ORIGINATION FORM

Proposed Revisions to a Standard Plans Index

Index Number: 425-001

Index Title: Supplementary Details for Drainage Structures

PIPE TO STRUCTURE FILTER FABRIC WRAP

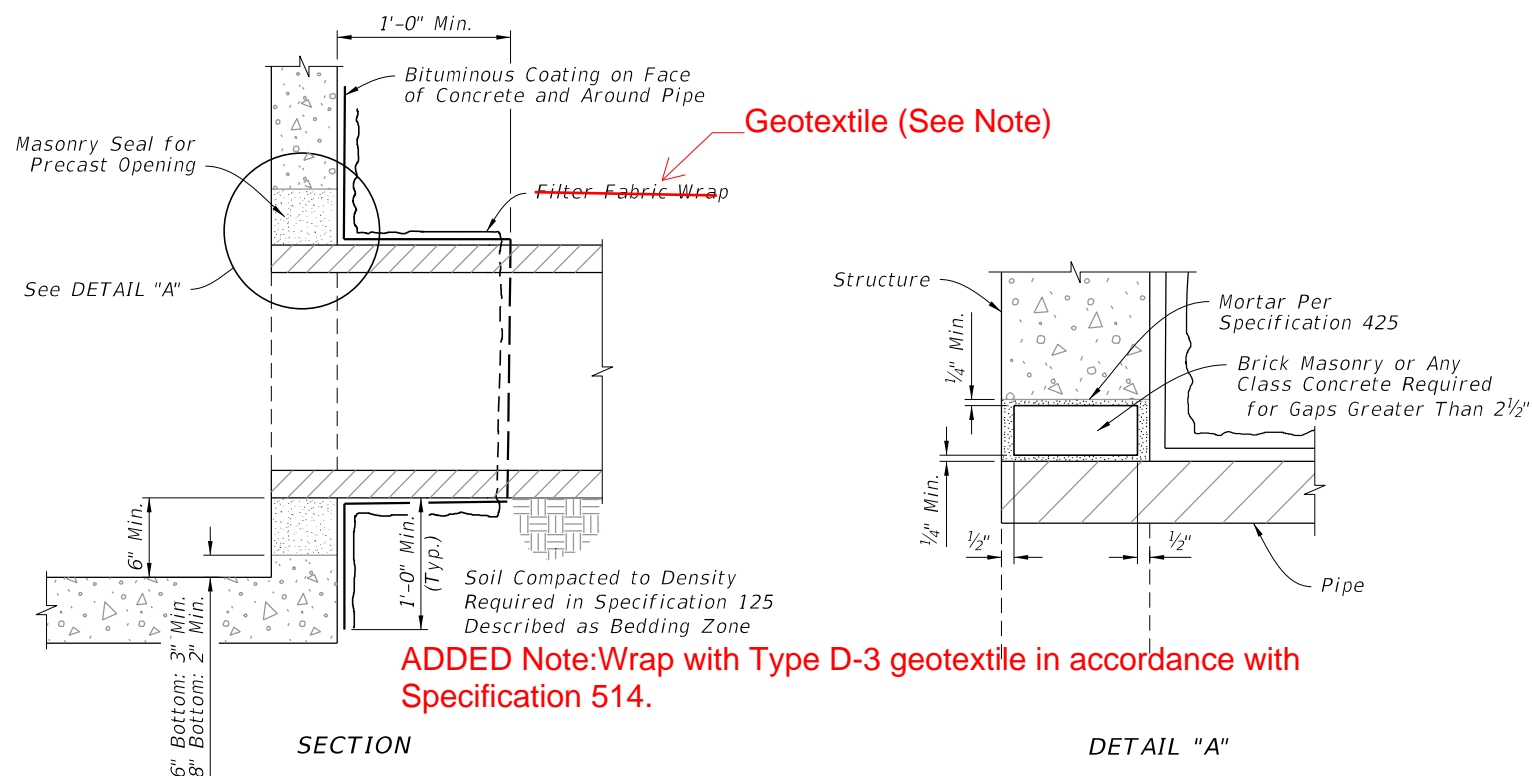
Sheet 3: Added Note "Wrap with geotextile in accordance with Specification 514." to the PIPE TO STRUCTURE FILTER FABRIC WRAP detail; Changed all references of "Filter Fabric" to "Geotextile".

Wrap with Type D-3 geotextile in accordance with Specification 514.

PIPE TO STRUCTURE GEOTEXTILE WRAP

SUMP BOTTOM

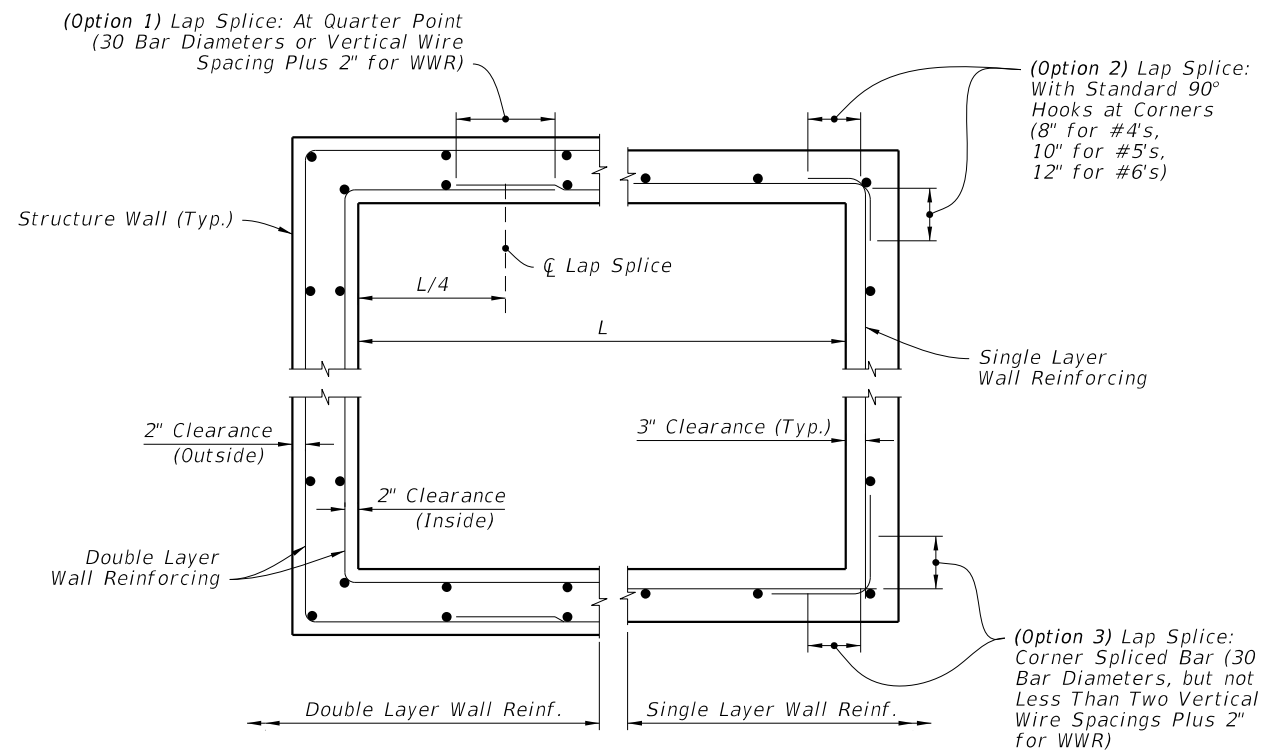
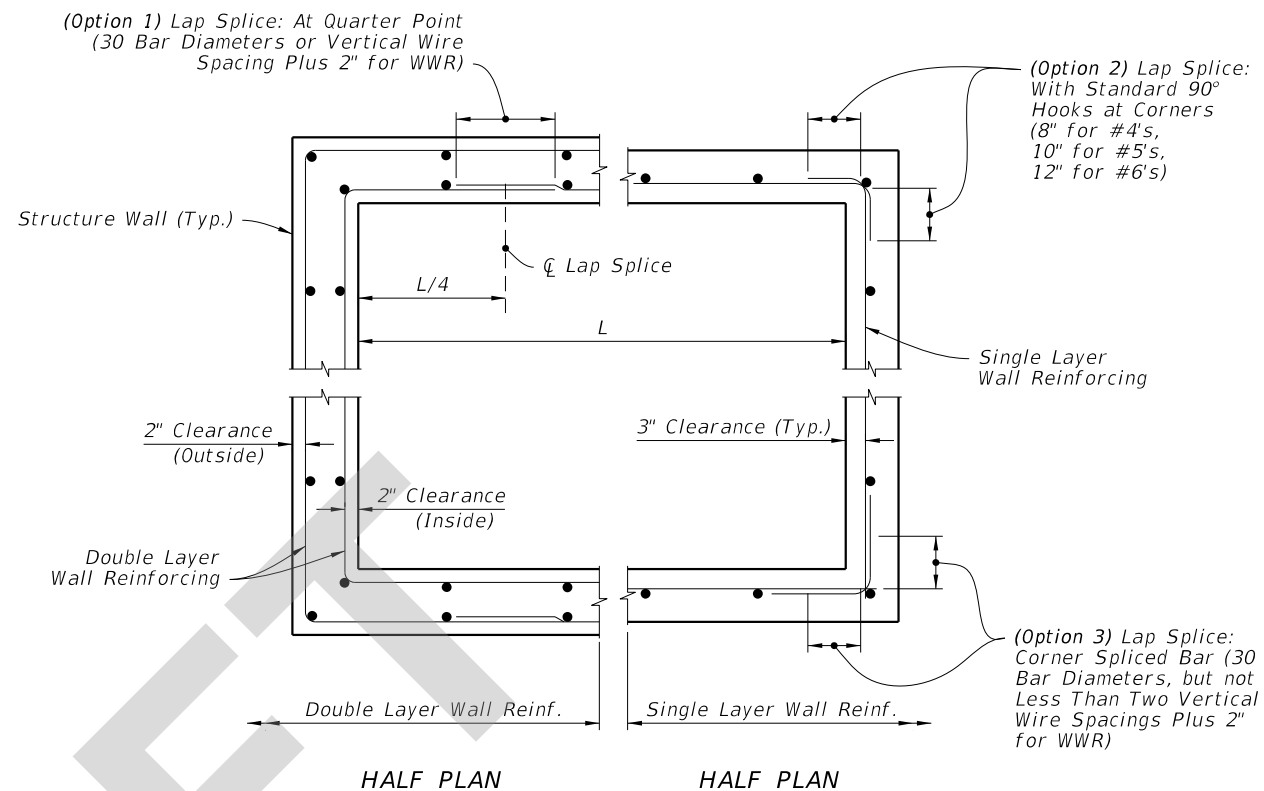
Sheet 4: Added Note 4 "Install Type D-3 geotextile in accordance with Specifications 514." to the SUMP BOTTOM detail.; Changed all references of "Filter Fabric" to "Geotextile".

Note 4: Install Type D-3 geotextile in accordance with Specifications 514.

1. Construct sumps in inlets and manholes connecting to French Drains unless excluded in the Plans.
2. Construct sumps only where called for in the Plans at all other locations.
3. Construct weep holes in sump bottom only where called for in the Plans.
4. Install Type D-3 geotextile in accordance with Specification 514.
